TITLE Broken Head Reserve Road Parking / Pedestrian Access Mark-up

DRAWING STATUS: For Community Review

DRAWING NUMBER: BHHR – S3

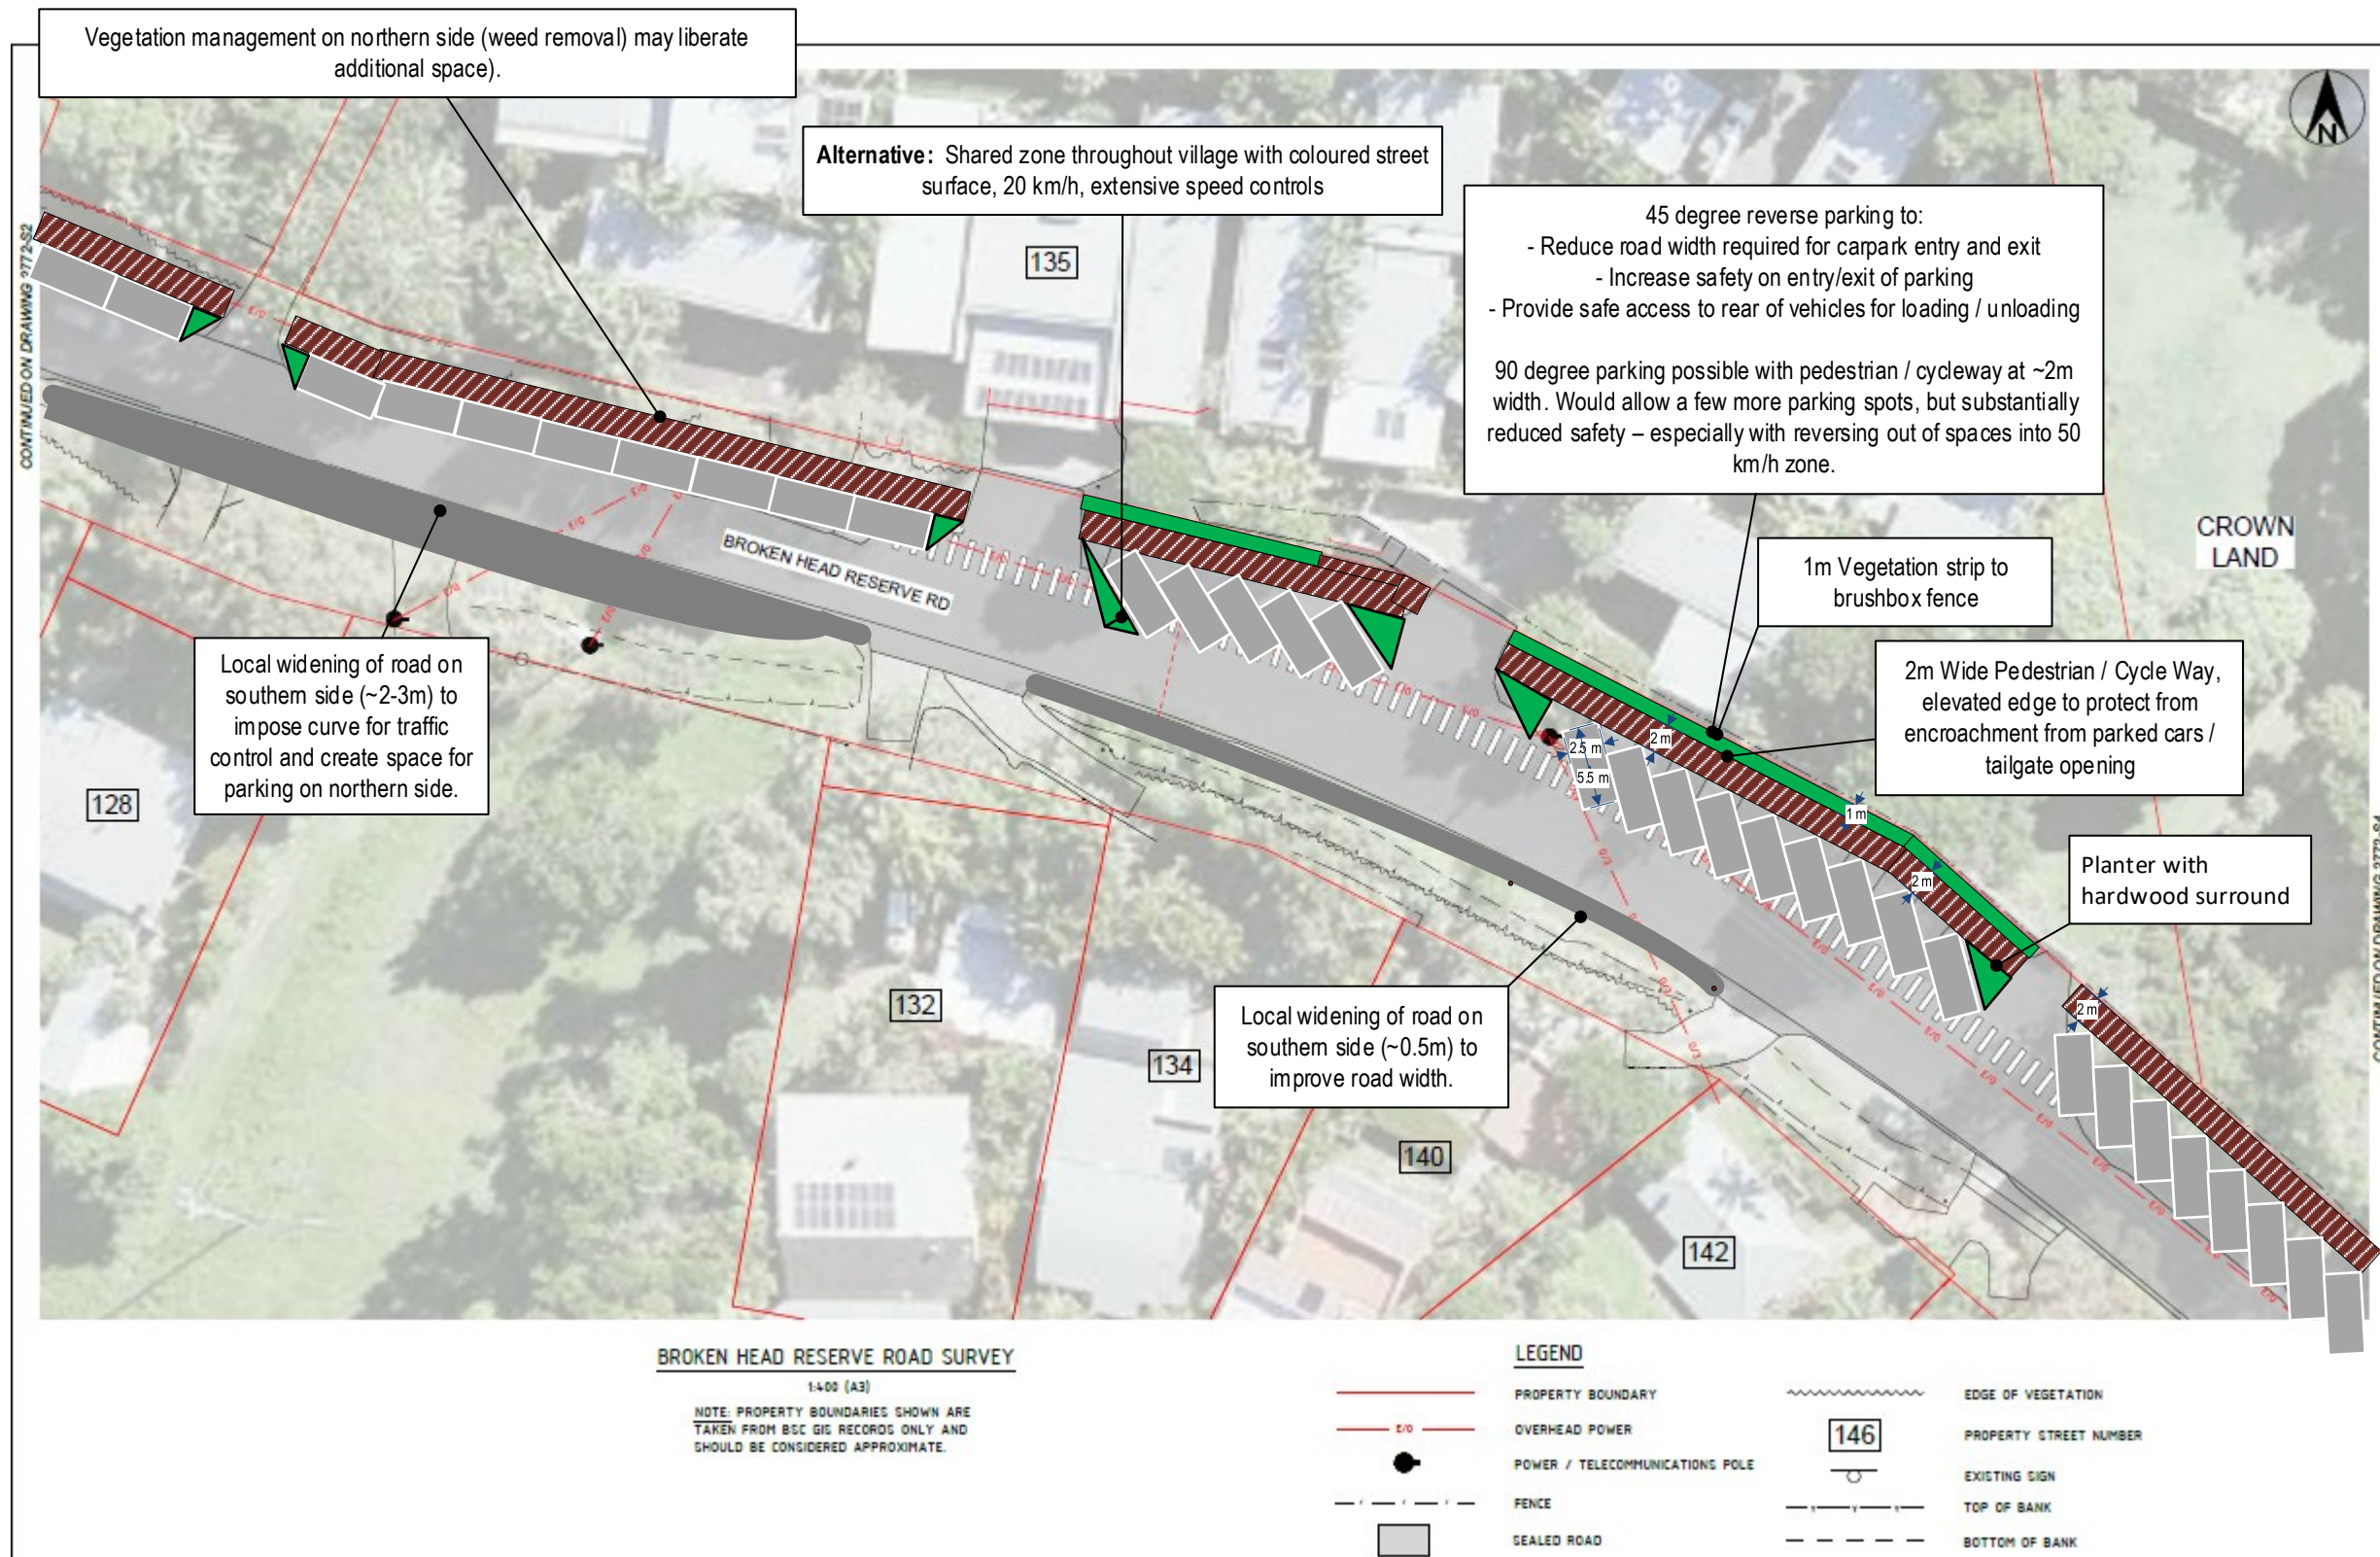
Additional considerations:

- Parking permits for residents' visitors.
- Speed zone review.

BROKEN HEAD RESERVE ROAD SURVEY
1:400 (A3)

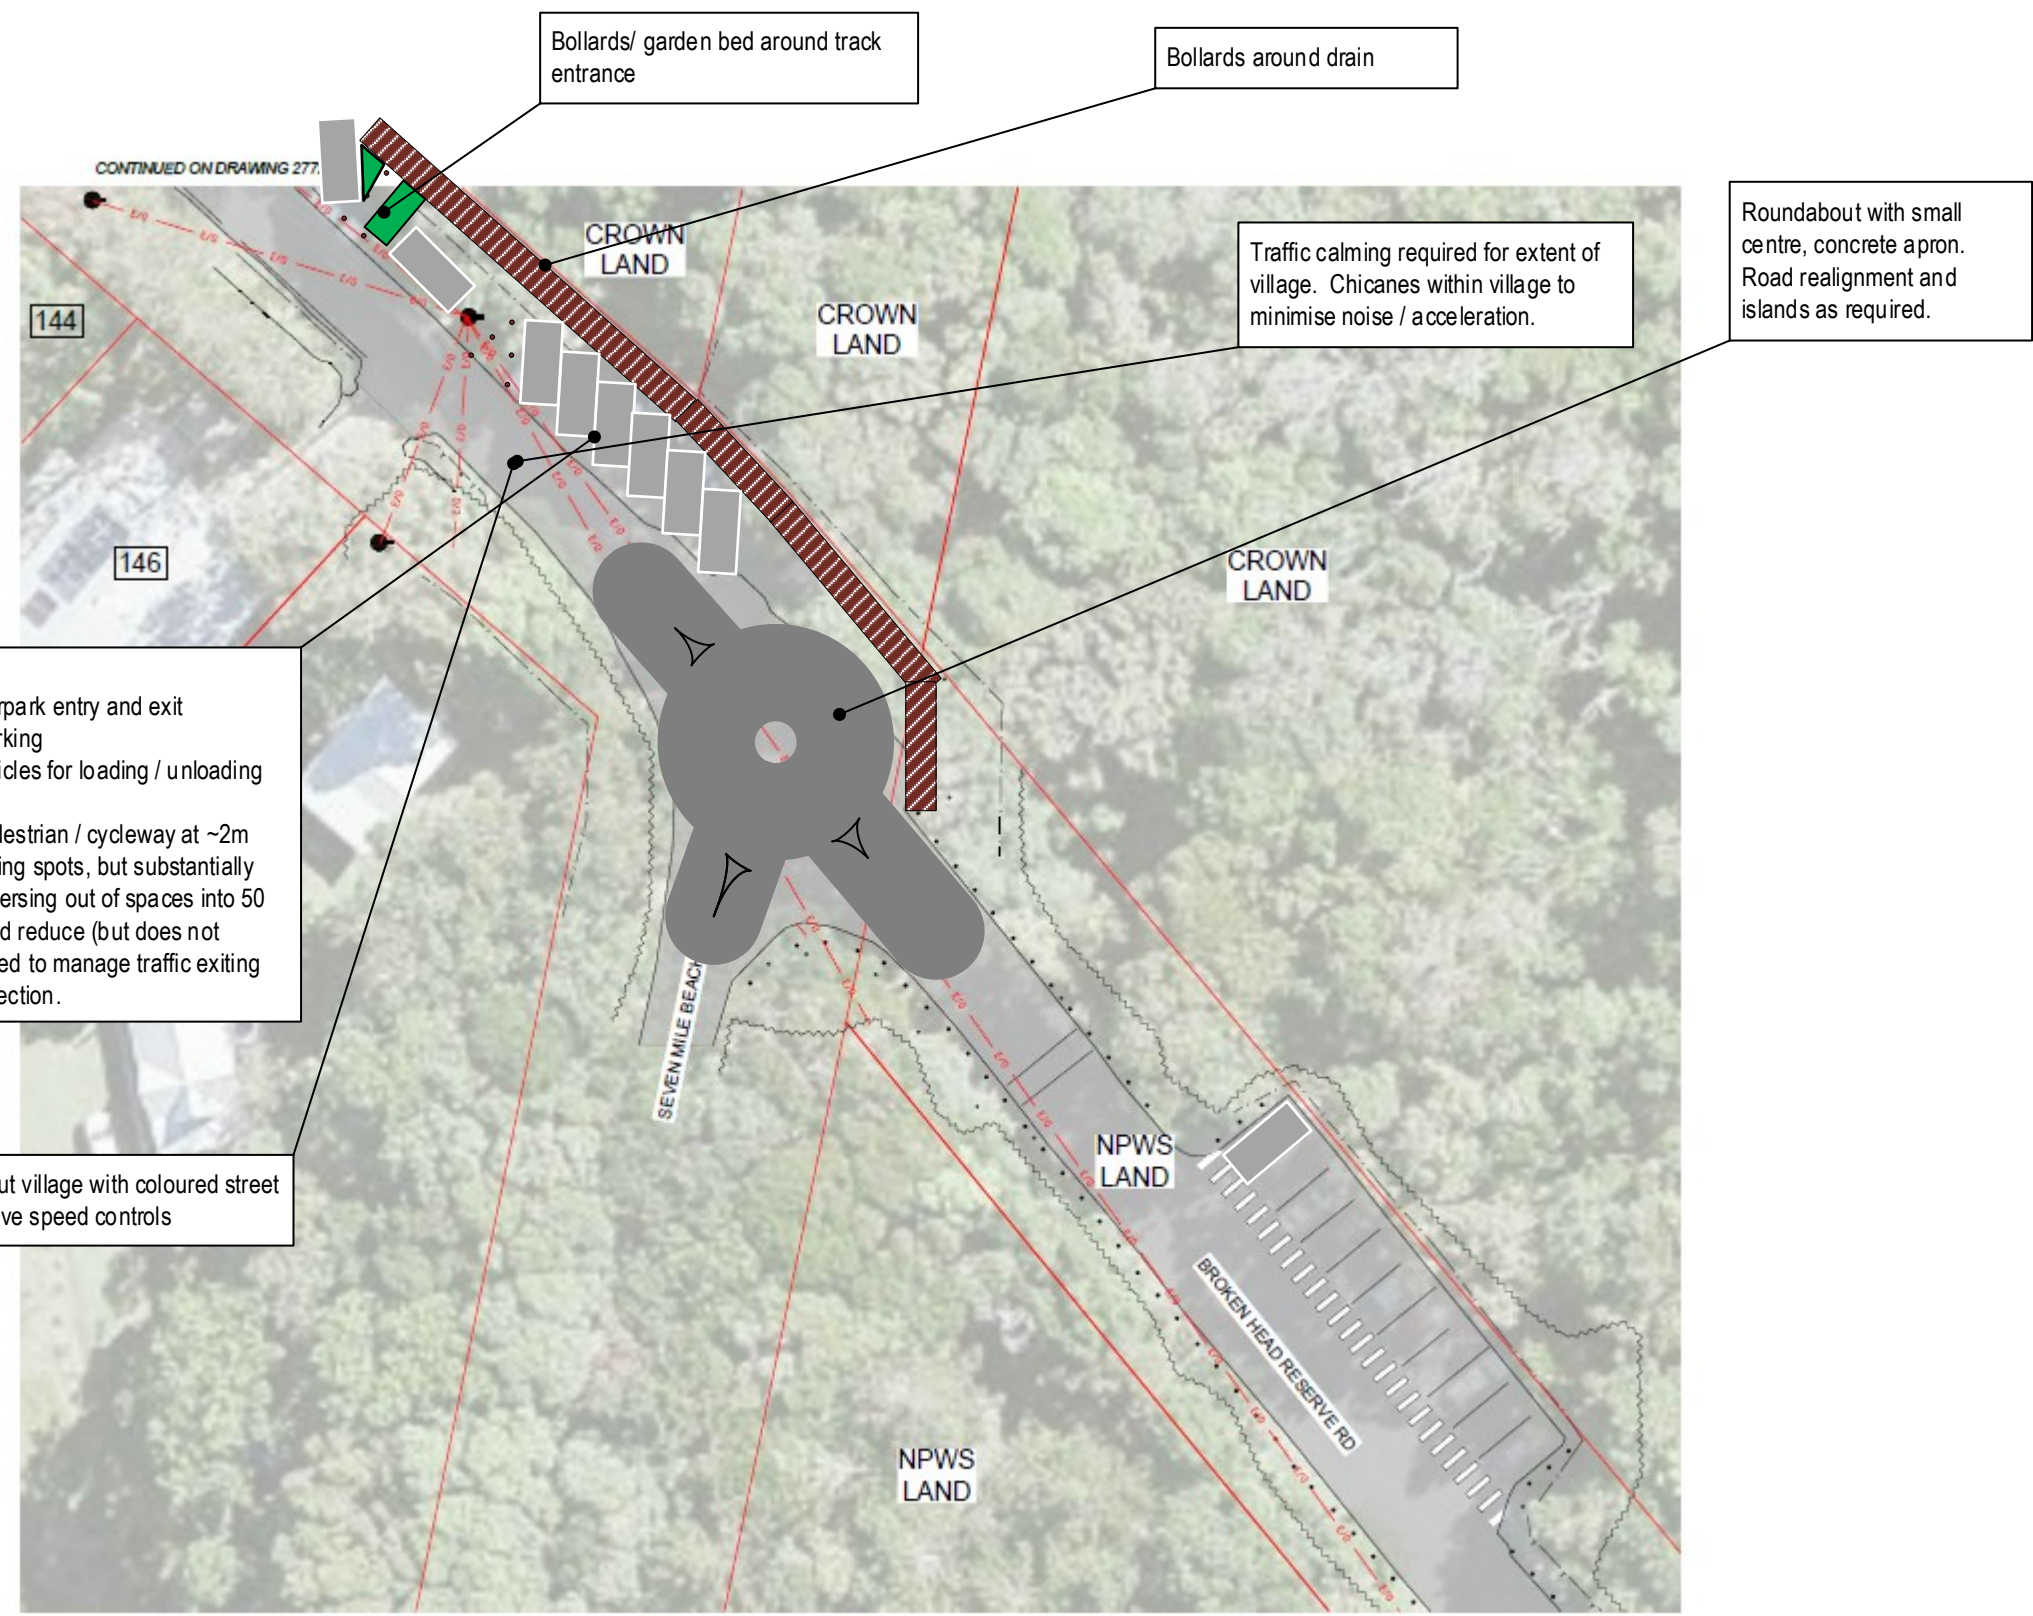
45 degree reverse parking to:

- Reduce road width required for carpark entry and exit
- Increase safety on entry/exit of parking
- Provide safe access to rear of vehicles for loading / unloading

90 degree parking possible with pedestrian / cycleway at ~2m width. Would allow a few more parking spots, but substantially reduced safety – especially with reversing out of spaces into 50 km/h zone. 90 degree parking would reduce (but does not eliminate) need for roundabout. Need to manage traffic exiting from parks in reverse into the intersection.

Alternative: Shared zone throughout village with coloured street surface, 20 km/h, extensive speed controls

Bollards/ garden bed around track entrance

Bollards around drain

Traffic calming required for extent of village. Chicanes within village to minimise noise / acceleration.

Roundabout with small centre, concrete apron. Road realignment and islands as required.
